Addendum Number One

Date of Issue: 05/23/14

Project: USC Gambrell Refit 4th Floor Office into Classroom
Project Number: CP00393371/FM00452461

**GAMBRELL HALL
REFIT 4TH FLOOR OFFICE INTO CLASSROOM**

SCALE: 1/4"=1'-0"

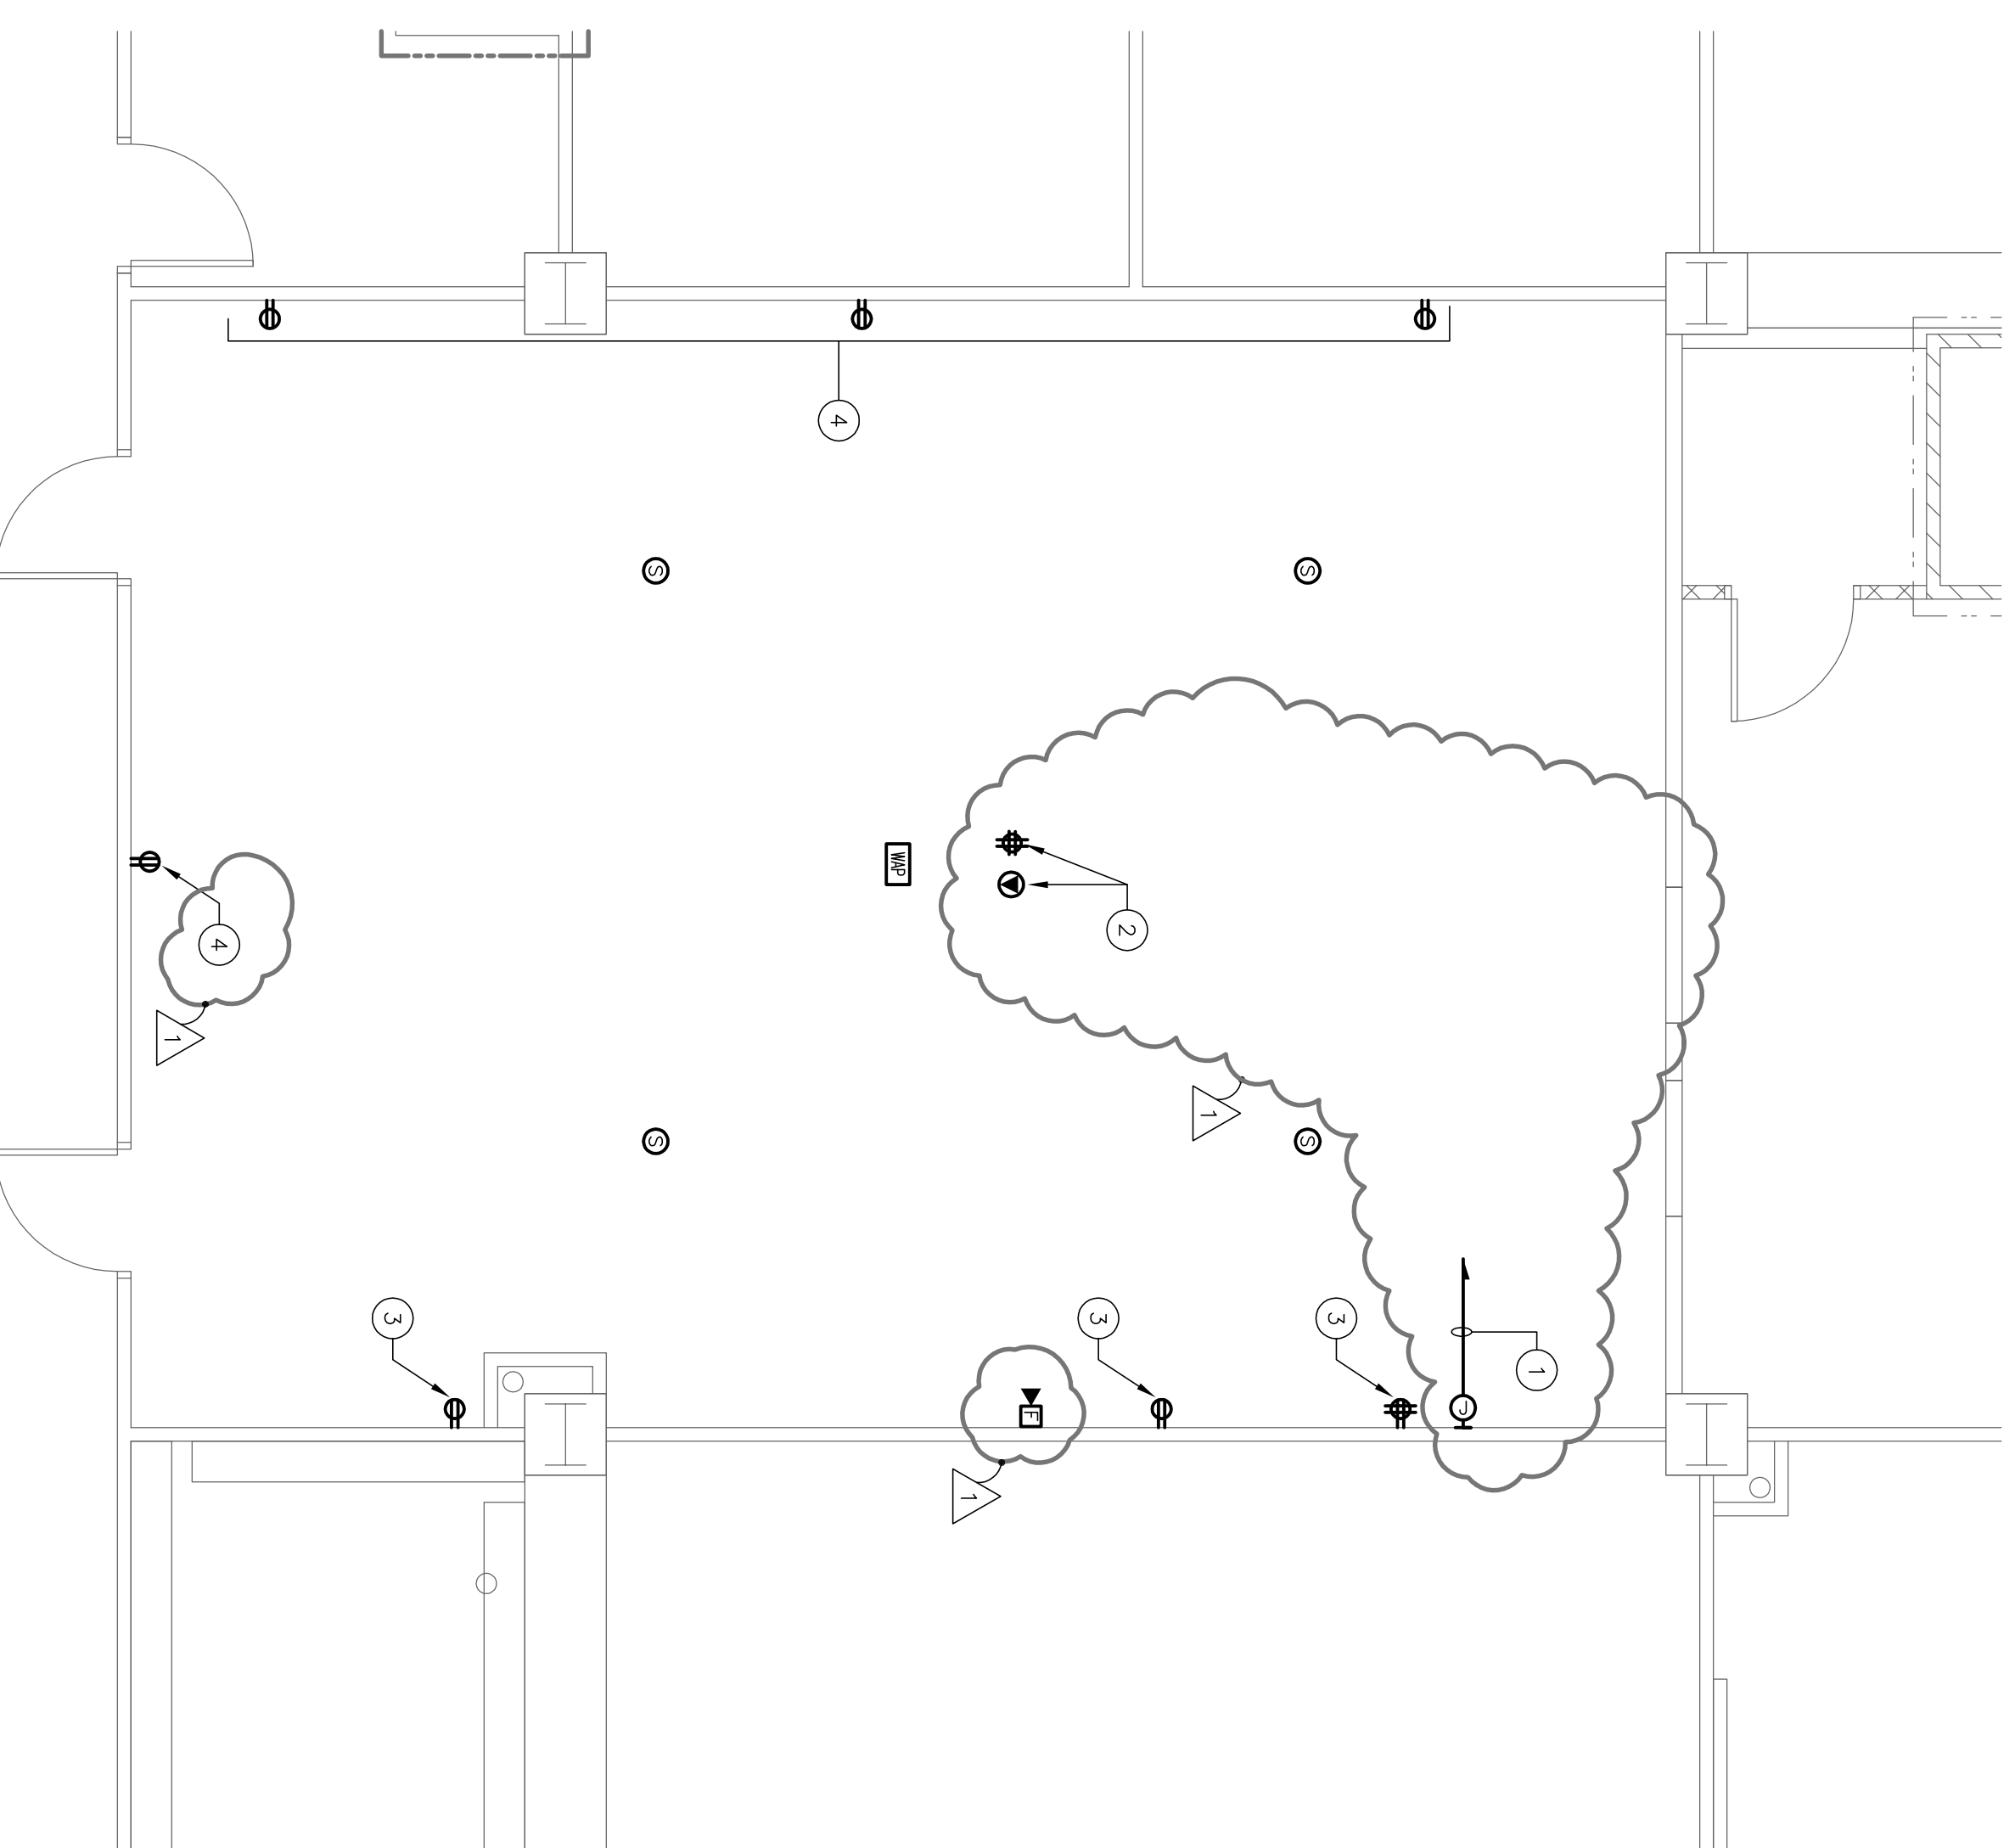
1. **SHEET A101 / Ceiling Renovation Notes** Delete Note H.
2. **SHEET E1.01 Fourth Floor Plan Electrical** Replace Sheet E1.01 with the attached sheet E1.01 dated 5/22/14. Revise the requirements for Audio/Visual rough-ins as shown.

- ① PROVIDE 1" CONDUIT FOR A/V CONNECTIONS PROVIDE TWO GANG DEEP CABLING PROVIDED BY UT, TO ABOVE CEILING FOR ROUGH-IN ONLY.
- ② PROVIDE POWER AND A/V FOR CEILING MOUNTED PROJECTOR. PROVIDE CEILING MOUNTED TWO-GANG DEVICE BOX AND QUAD-DUPLEX RECEPTACLE AS REQUIRED.
- ③ CONNECT RECEPTACLE TO NEAREST 20 AMP CIRCUIT. EXTEND REMAINING CIRCUIT AS REQUIRED.
- ④ PROVIDE RECEPTACLE AND COVER PLATE. CONNECT TO EXISTING BRANCH CIRCUIT WIRING.
